Notice of Allowability

10/815,573

YE ET AL.

FIGURE 1 PRIOR ART

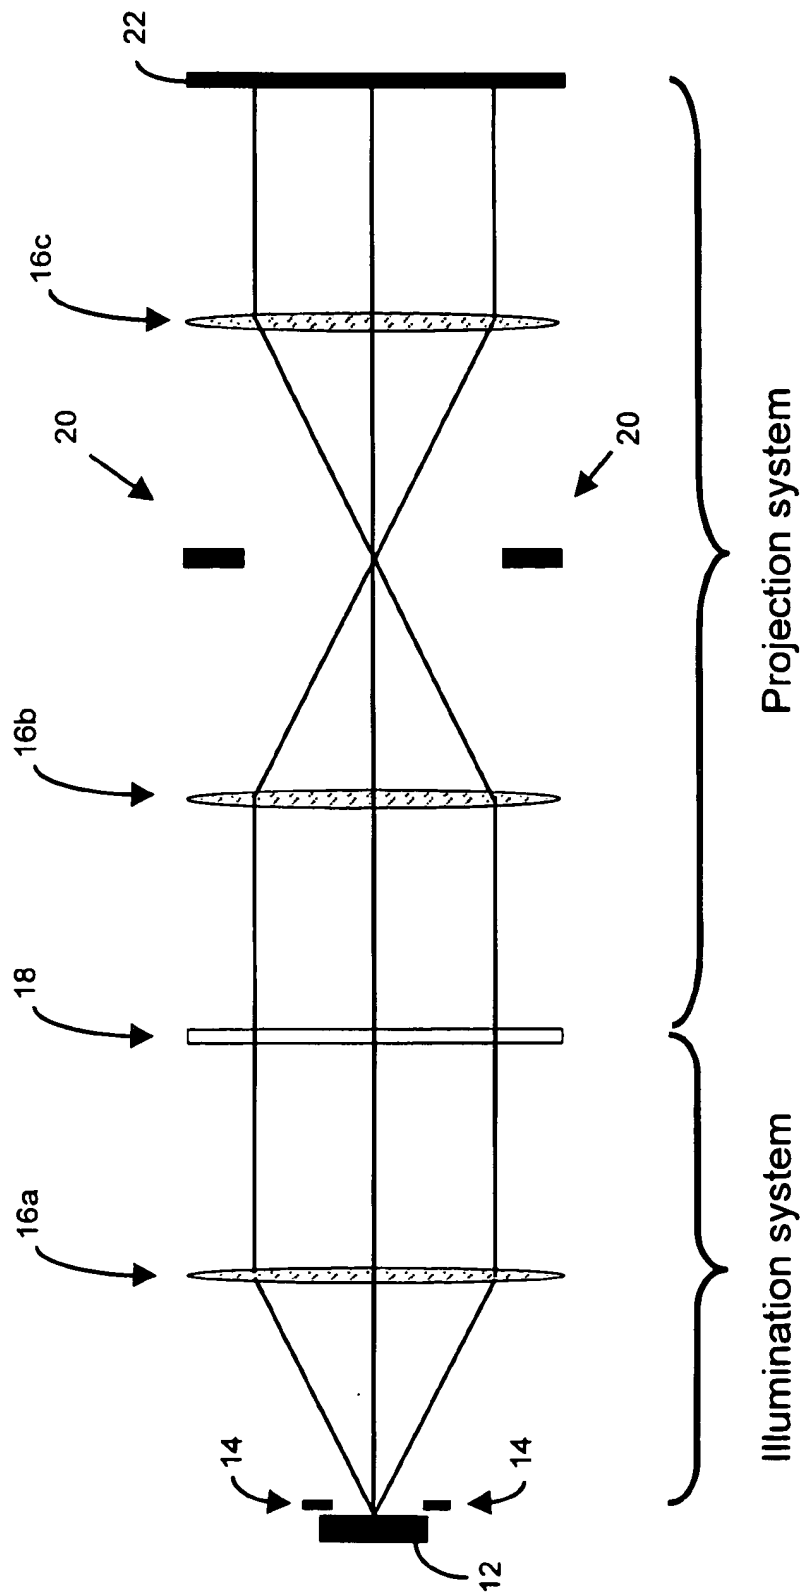
--Prior Art-- has been inserted to Figures 1, 2A and 2B as shown in the attached drawing sheets.

3. The following changes to the drawings have been approved by the examiner and agreed upon by applicant: --Prior Art-- label has been added to Figures 1, 2A and 2B as given in the Examiner's Amendment above and shown in the attached drawing sheets, since only that which is old is illustrated (see page 2 of Applicant's specification; see MPEP § 608.02(g)). In order to avoid abandonment of the application, applicant must make these above agreed upon drawing changes.
